# PAGE INSERTION GUIDE

RESPONSE TO NRC QUESTIONS  
CONTAINED IN THE NRC'S  
LETTER OF SEPTEMBER 28, 1979

FIGURE 2-16 MODULE SUPPORT SYSTEM

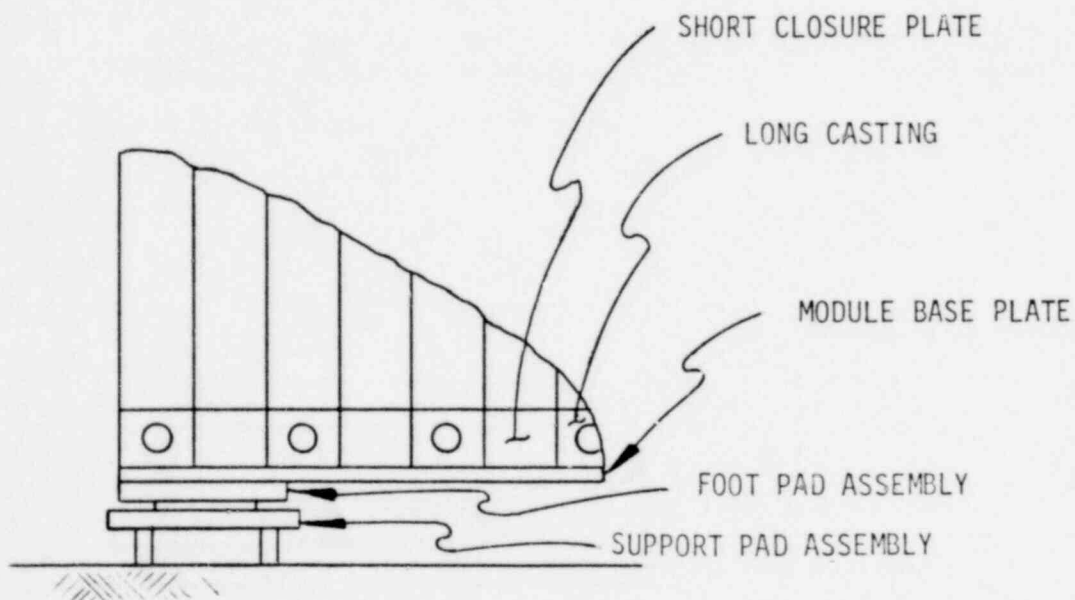
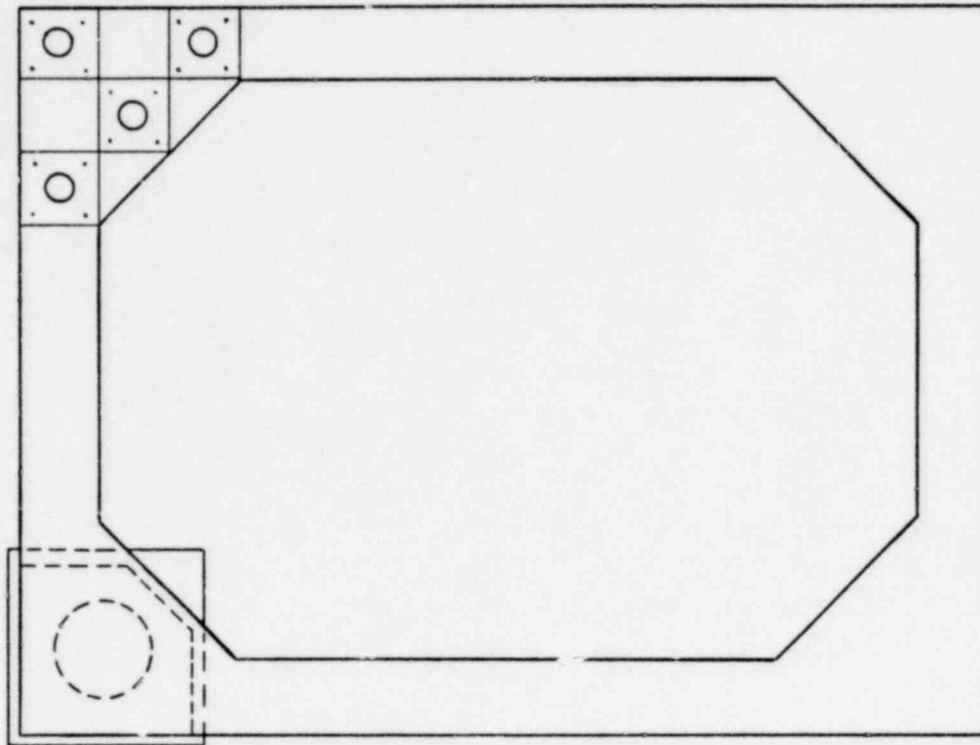
Provide sufficient detail of the base plates, foot pads, the support pads, all gaps of the rack structure and all sliding surfaces of the racks.

The module support system consists of a module base plate, four foot pad assemblies, and four support pads. The support pads rest on the pool floor. They are fabricated from 2-inch-thick stainless steel plate, and are 19 inches square in plan and 6 inches high. The 2-inch-thick foot pads rest on the 6-inch-thick support pads to raise the module base plate a minimum of 8 inches above the floor of the fuel pool, allowing sufficient area to clear the existing swing bolts on the pool floor, and to permit natural circulation of cooling water to the modules without taking credit for sources of forced cooling.

The foot pad assemblies are bolted to the module base plate at each of the four corners. The foot pad assembly consists of a 3/4-inch-thick by either a 12- or 15-inch-diameter plate made from special low-friction material which is pressed into a 1/2-inch-deep circular recess in a 2-inch-thick stainless steel plate. The 2-inch stainless steel plate is 19-3/4 inches square with 10-1/2 inches at 45° cut off one corner to match the module base plate. The foot pad bears on the support pads. These are the only sliding surfaces for the modules.

The module base plate is fabricated from 1-inch-thick stainless steel plate. The long castings and short closure plates on the perimeter of the module are welded to the base plate.

The gap between all modules is a minimum of 2 inches. There are no other gaps in the module construction.

Figure 2-16 and Figure 2-17 illustrate the system described above.

Figure 4-10 Path of Earthquake Horizontal Forces in Module

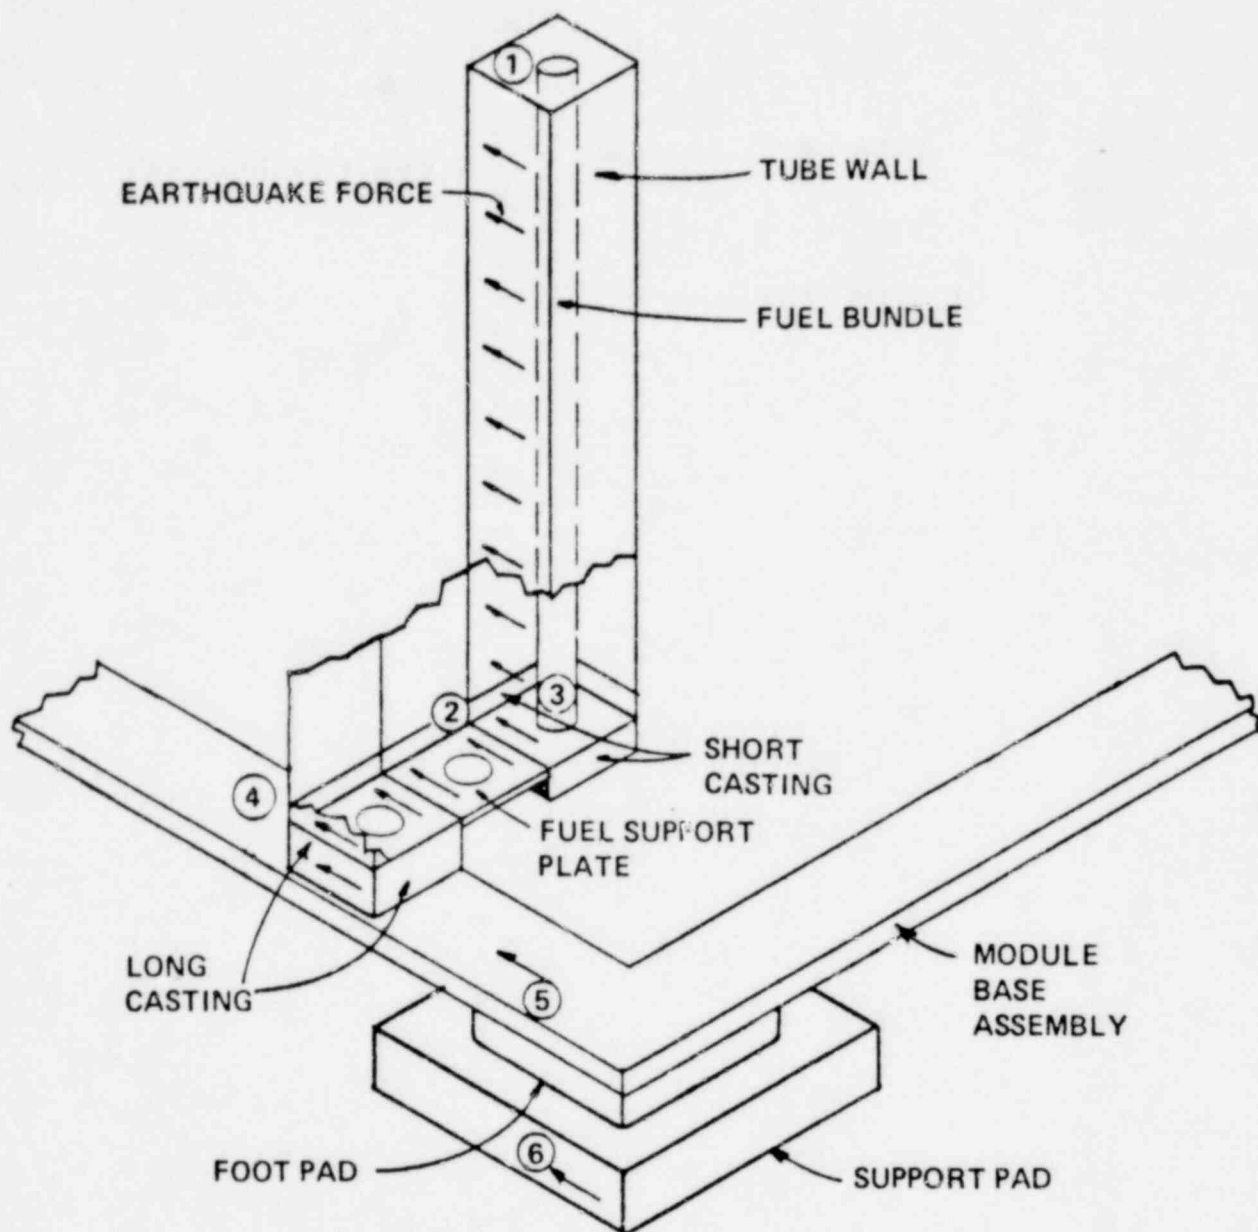
During seismic events (horizontal and vertical), part of the fuel bundle inertial forces is transferred directly to the tube wall or the fuel support plate through the clearance gaps. Indicate how these impactive motions have been considered in the analysis along with the effects of fuel storage rack rocking and sliding on the pool floor. Provide the numerical values for these impactive factors (dynamic amplification factors) and justifications.

The force path in the module caused by a horizontal earthquake is shown schematically in Figure 4-10. This figure shows the path of the horizontally induced earthquake fuel element inertial forces from the fuel element to the module support pads. Part of the fuel bundle inertial forces induced by the motion of the module are transferred either through the water or directly to the tube walls perpendicular to the direction of motion (Point 1 in Figure 4-10). These walls then transfer the forces to the side tube walls, which carry the forces down the walls and into the fuel support plates (Point 2). The portion of the fuel bundle load which is not transferred to the fuel tube walls is transferred directly to the fuel support plate at the point where the lower end fitting of the fuel bundle is supported vertically (Point 3). The fuel support plates, acting as a relatively rigid diaphragm, transfer the in-plane shear forces to the long casting which then transfers the shear forces to the module base assembly plate (Point 4). The forces are carried in the module base assembly (Point 5) until they are ultimately transferred to the foot pad and to the support pad and the pool slab (Point 6).
